CITY OF ALBUQUERQUE

**RE: Main Event, Pan American Freeway and Vassar Drive
Grading Plan and Drainage Plan
Engineer's Stamp Date 5-07-2015 (File: G16-D149)**

DRAINAGE AND TRANSPORTATION INFORMATION SHEET

**RE: MAIN EVENT,
PAN AMERICAN FREEWAY AND VASSAR DRIVE
GRADING PLAN AND DRAINAGE PLAN
ENGINEER'S STAMP DATE 3-27-2015 (FILE:G-D149)**

DRAWN BY
BJF

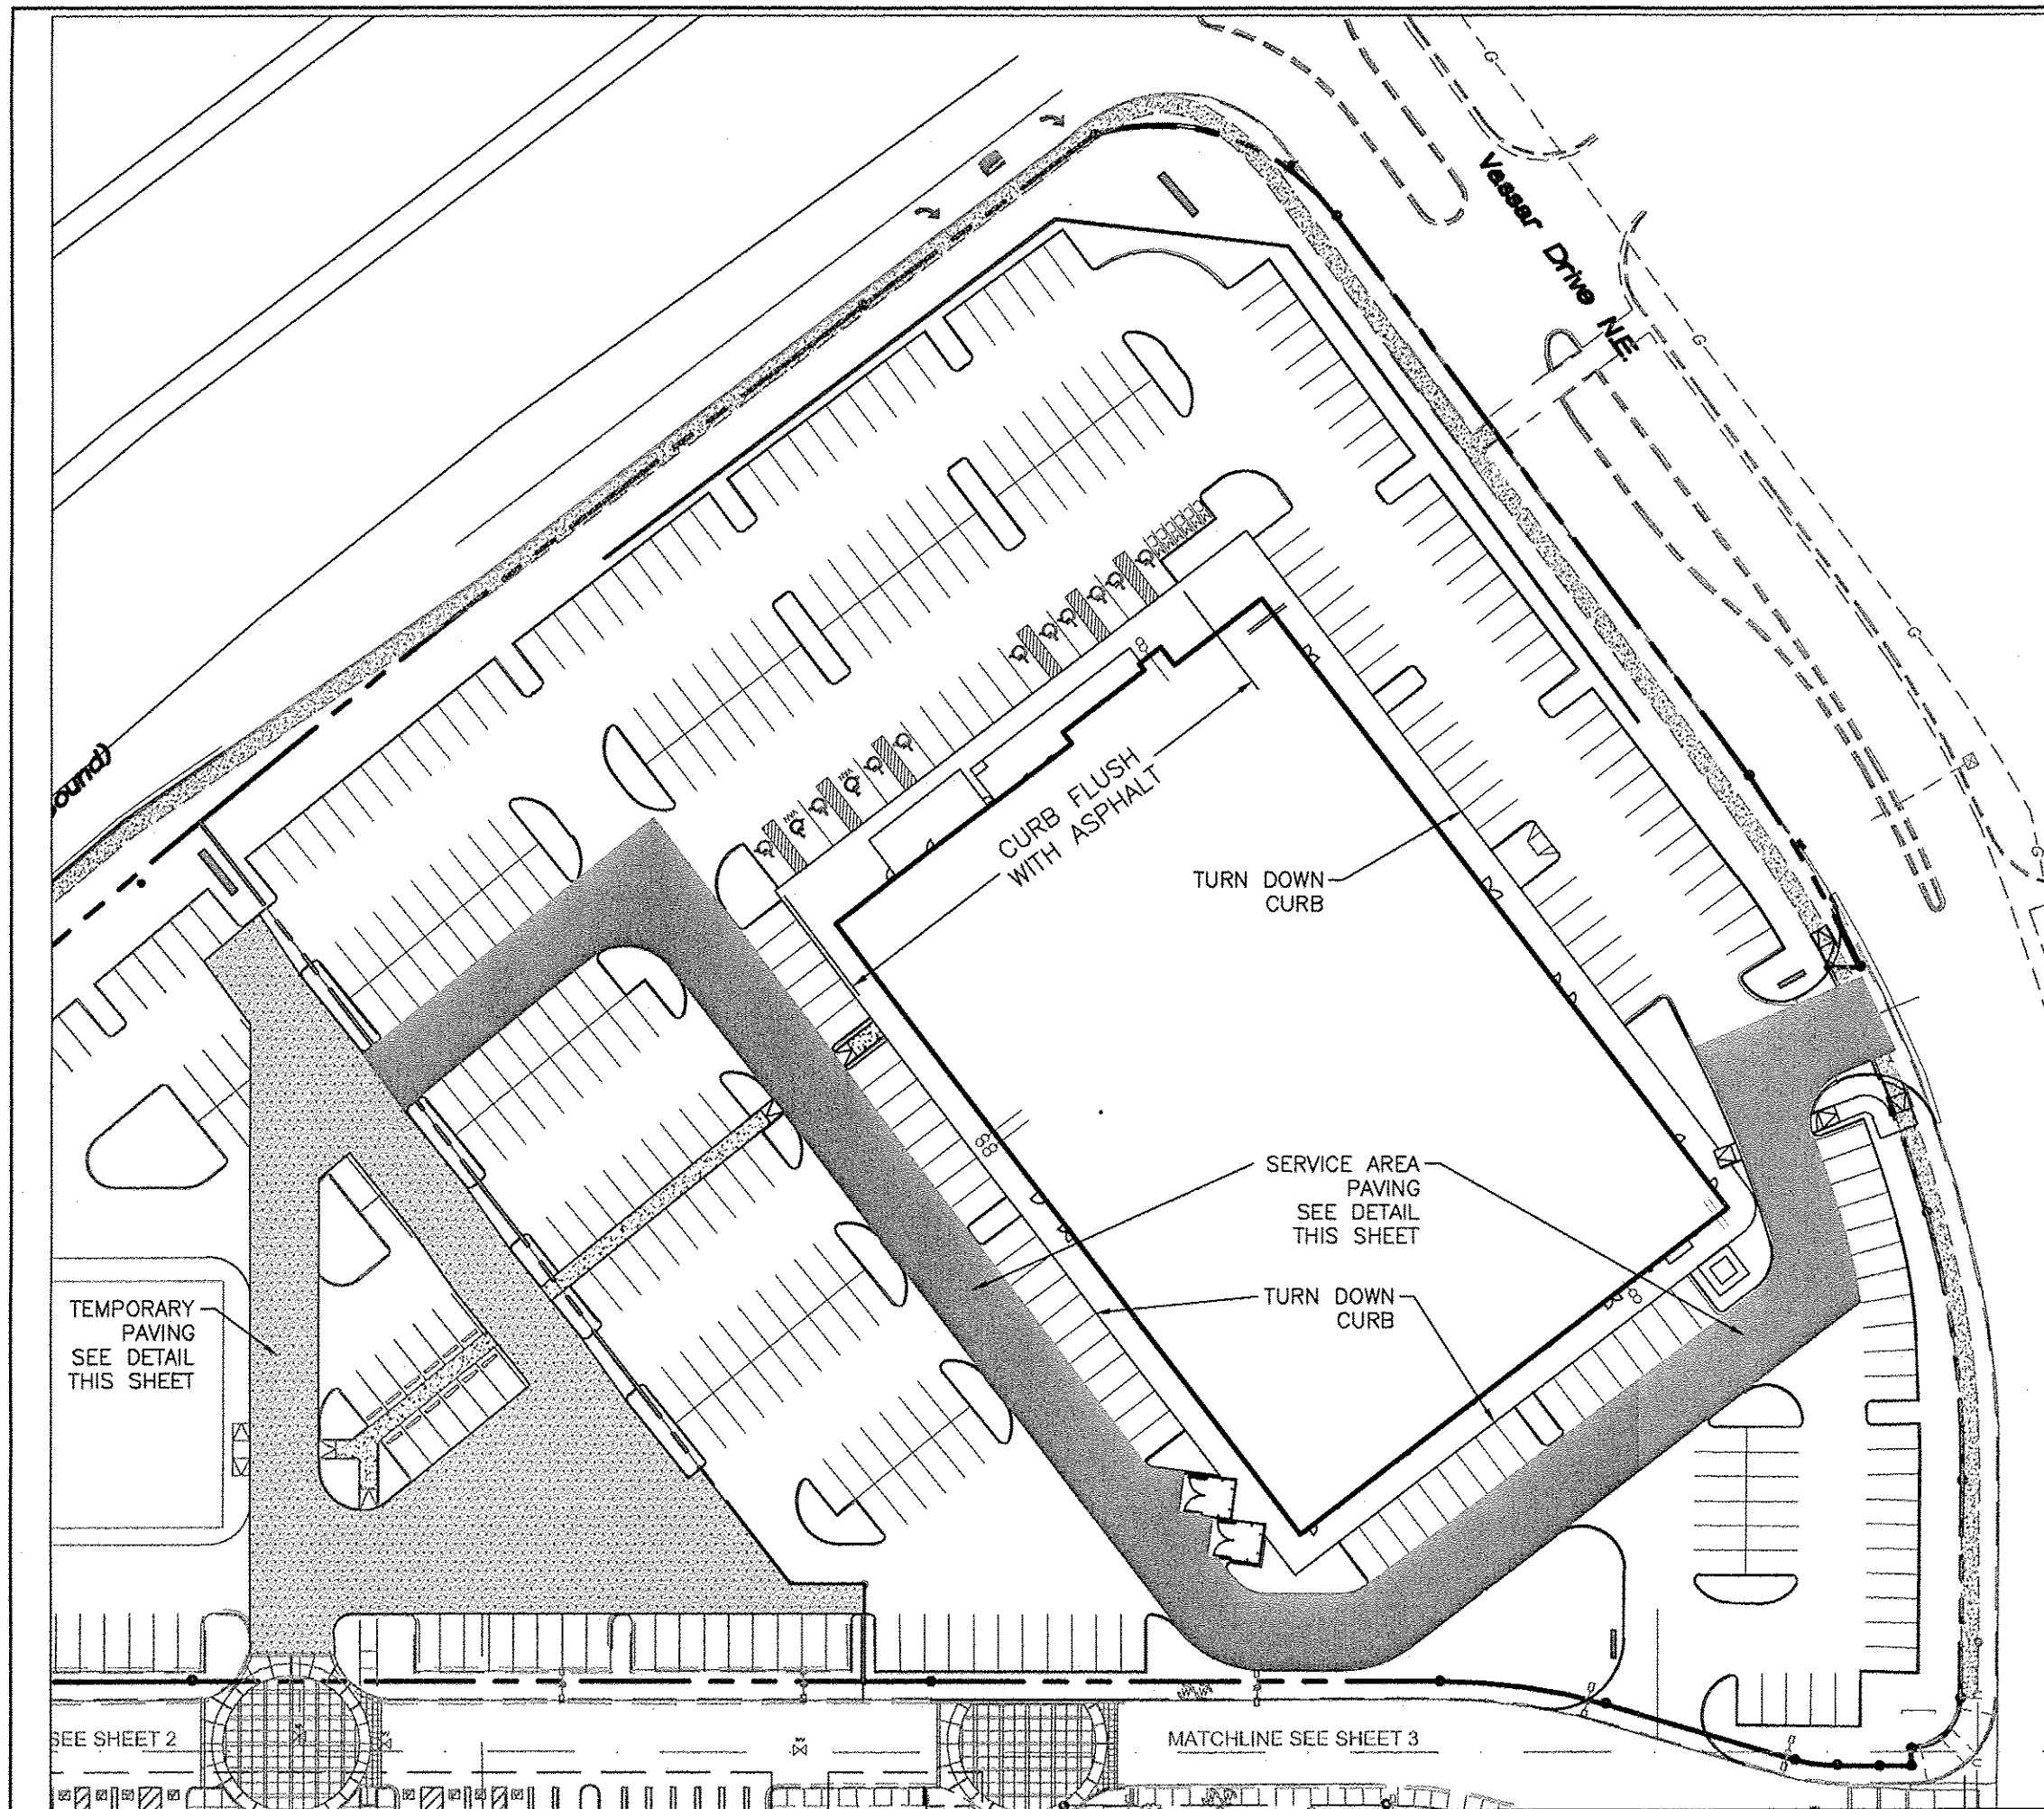
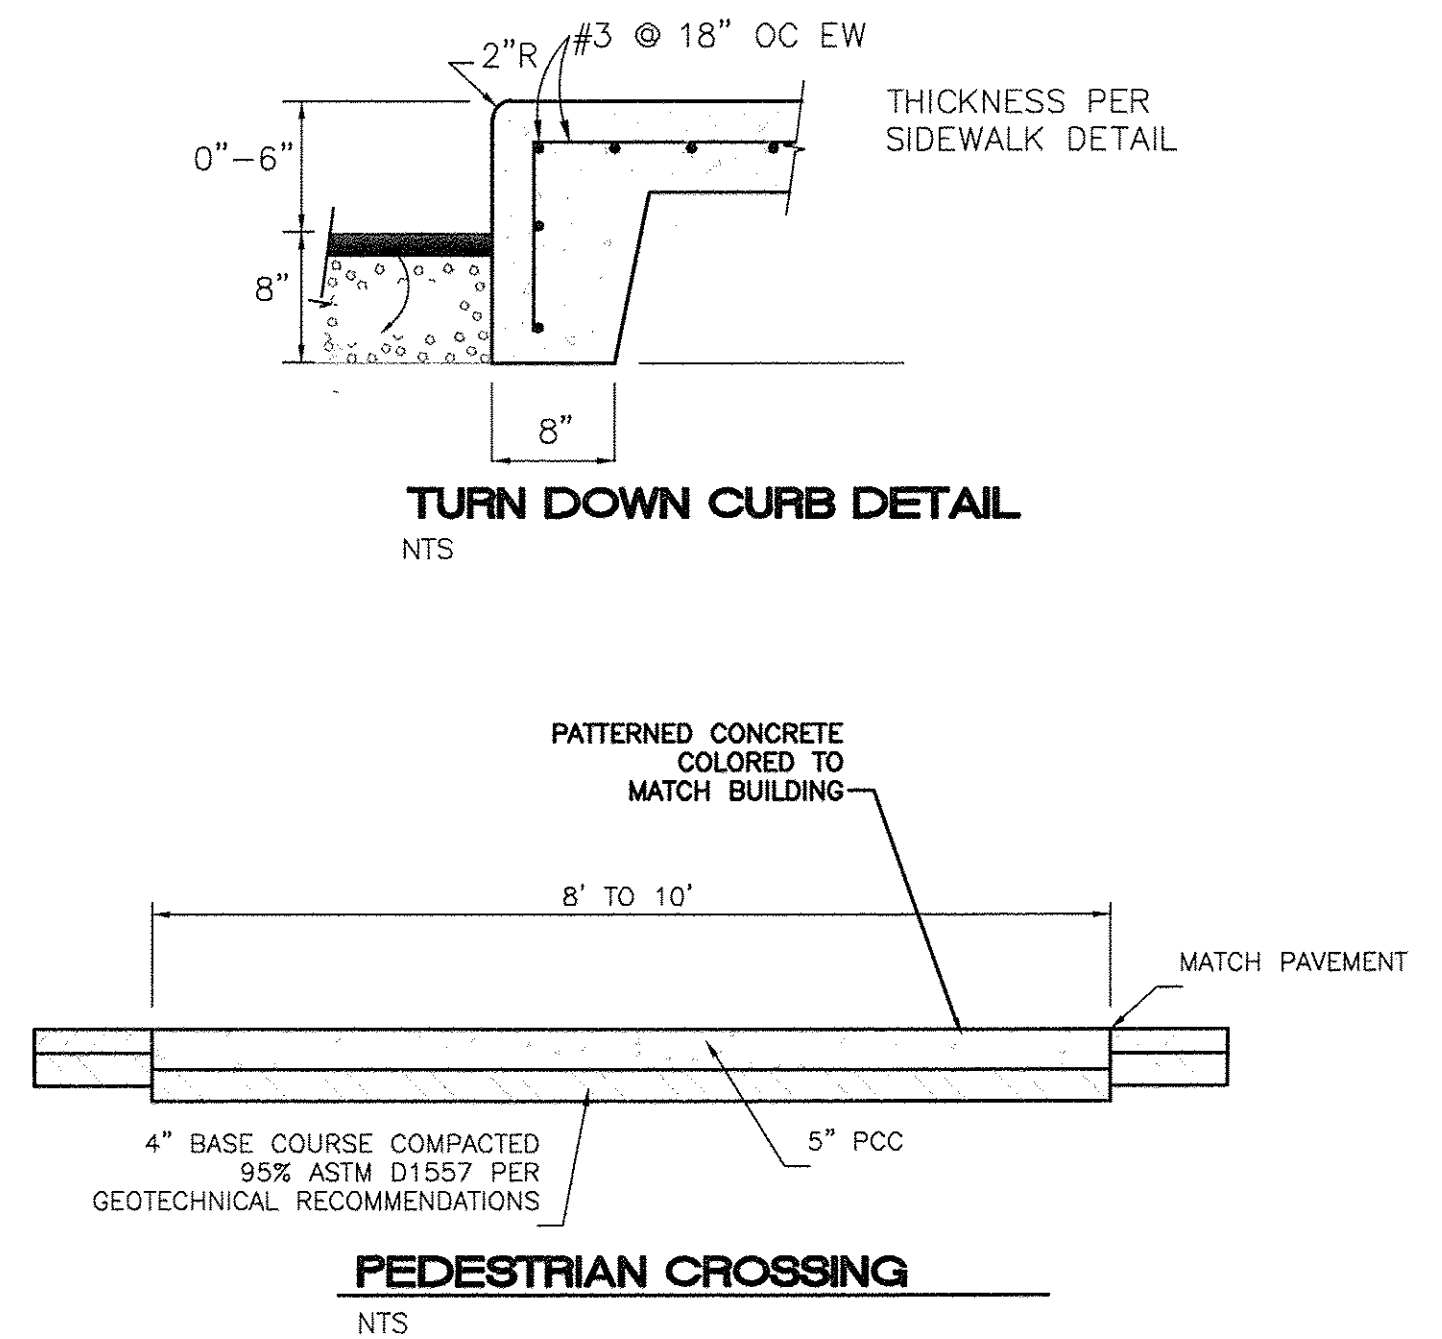
6. Include detail of the 8-foot modified manhole. **This detail was added to Sheet C17.**
